MODIFICATION PROPOSAL FORM

POWER QUALITY MODIFICATION

FORM GC1, PROPOSAL OF MODIFICATION TO GRID CODE.

MODIFICATION PROPOSAL ORGINATOR:	**EIRGRID**		
MODIFICATION PROPOSAL ORIGINATOR (CONTACT NAME)	**JOHN GING**	**MODIFICATION PROPOSAL ORIGINATOR FAX NUMBER:**	**+353-1-6615375**
MODIFICATION PROPOSAL ORIGINATOR TELEPHONE NUMBER:	**: +353-1-23 70391**	**DATE:**	10/10/2104
MODIFICATION PROPOSAL ORIGINATOR E-MAIL ADDRESS:	**JOHN.GING@EIRGRID.COM**	**MODIFICATION PROPOSAL NUMBER (EIRGRID USE ONLY)**	**MPID 264**
GRID CODE SECTION(S) AFFECTED BY PROPOSAL:	CC.10.13 (CC.10.13.1 – CC.10.13.4) OC. 10.2.2 WFPS.1.6.2.2 and WFPS.1.6.4 Definitions		
GRID CODE VERSION :	5

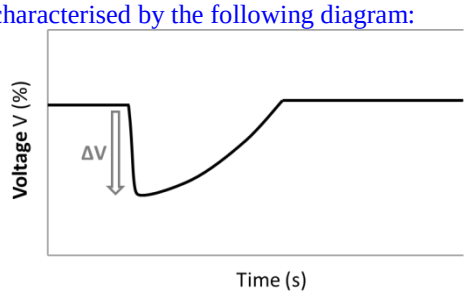
Temporary Voltage Depression	A rapid change in fundamental **Frequency RMS** or peak **Voltage** over several cycles and remaining within the normal operating voltage range. This form of disturbance can manifest as an **RMS Voltage** depression with a slow recovery to nominal **Voltage**. The **RMS Voltage** depression is attributable to starting motors or the energisation of transformers or reactors and is characterised by the following diagram:
